Washington Public Power Supply System

Docket 50-508

Subject: NUCLEAR PROJECT 3
FIGURES FOR ACCEPTANCE REVIEW QUESTIONS

Question No.

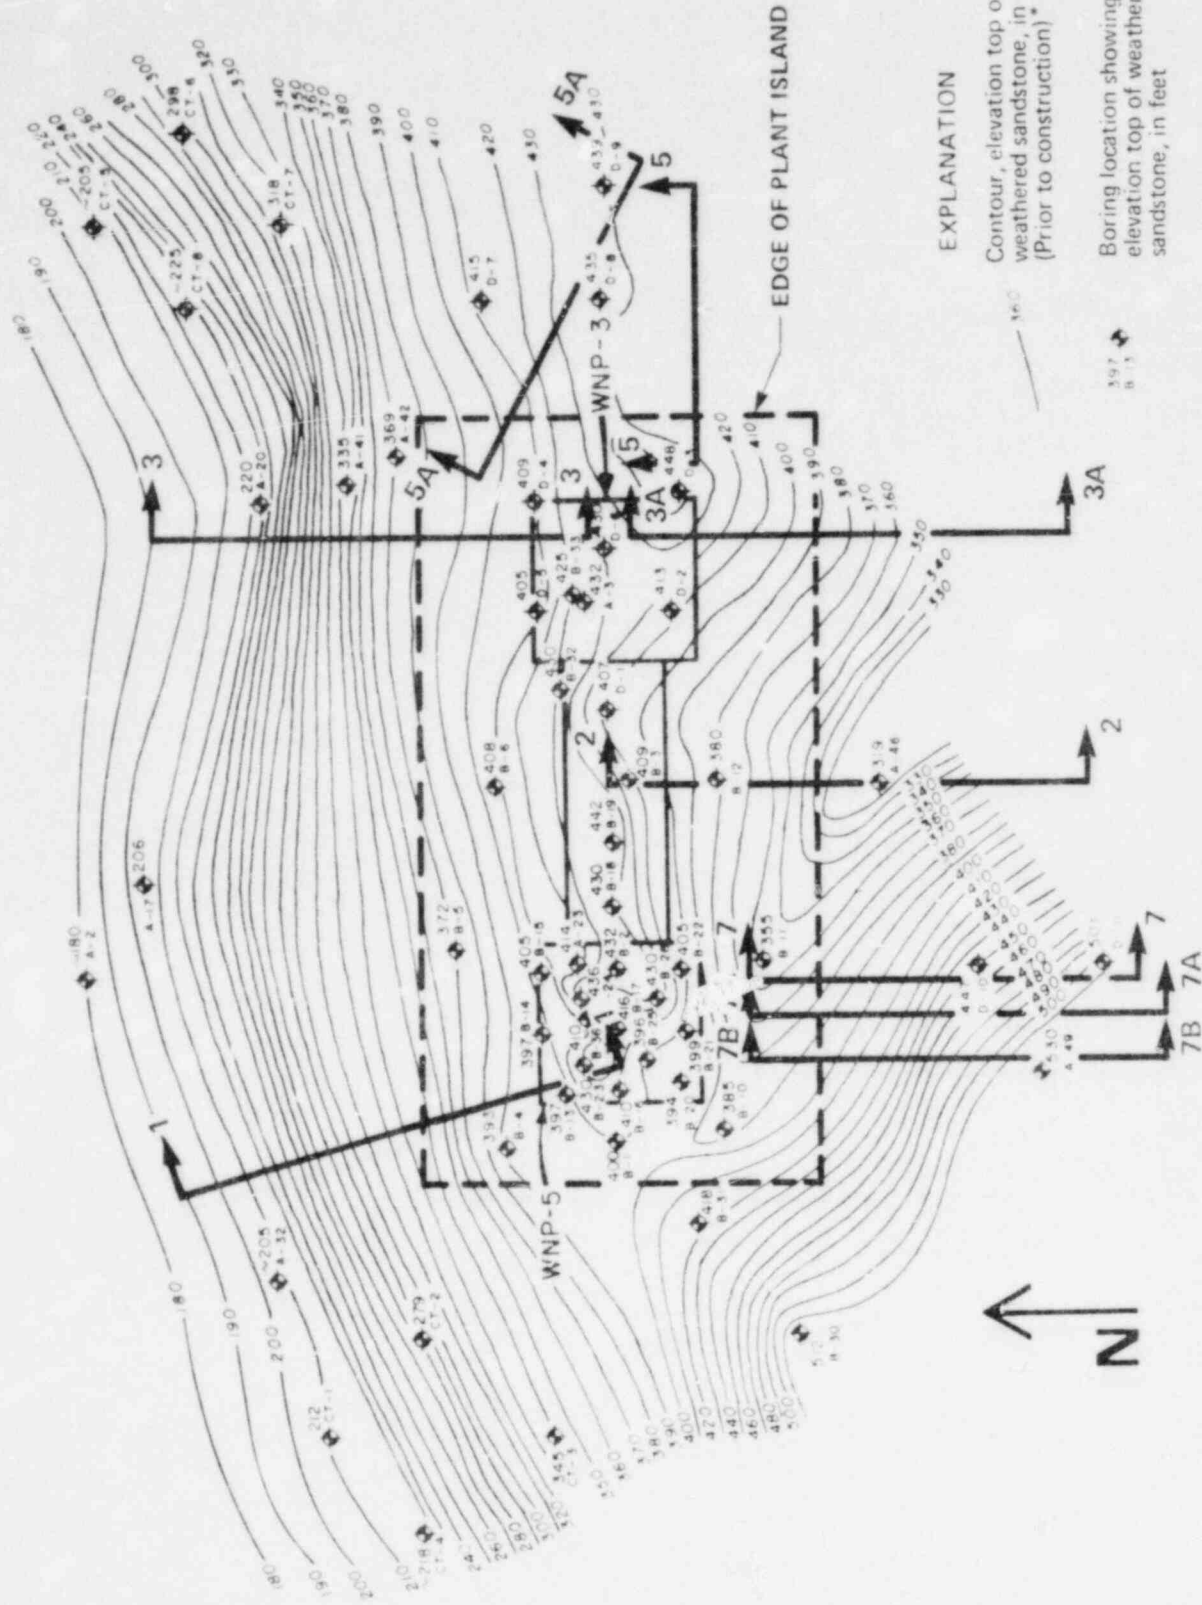
Describe in detail the procedure you used for calculating the subgrade stiffness that was used in MSC/NASTRAN for the analysis of the Category I Tank Enclosure Structure, and provide the values of the geotechnical parameters for staff review. Also provide the foundation loading results and factors of safety with respect to sliding and overturning of this structure for SSE conditions and reference results to Subsection 2.5.4.

The subgrade stiffness for the analysis of the Category I Tank Enclosure Structure was calculated using

$$(1) \quad K_s = \frac{2.16G}{R_d (1-\mu) \sqrt{A}}$$

where: K_s = Modulus of subgrade reaction

G = 330 Ksi from Figure 2.5-121

μ = 0.40 from Table 2.5-16

A = Area but to a maximum of $10m^2$

R_d = reduction factor which varies from 5 to 20 to convert from laboratory data to field data.

Equation (1) was obtained from "Dynamics of Bases and Foundations" by D. D. Barker, McGraw Hill, 1962.

Substituting the indicated values into Equation (1) and using the maximum reduction factor for conservatism, a value for K_s of 500 #/in^3 was determined and used in the static analysis for the Tank Enclosure Structure.

The factors of safety against sliding and overturning for the Tank Enclosure Structure and respectively, 1.6 and 1.5 (see Subsection 3.7.2.14) for SSE condition. The maximum bearing pressure (also due to SSE) is $6.0K/ft^2$. The bearing capacity of weathered sandstone, on which the tank enclosure structure is founded, is $50K/ft^2$ (factor of safety is 8.3).
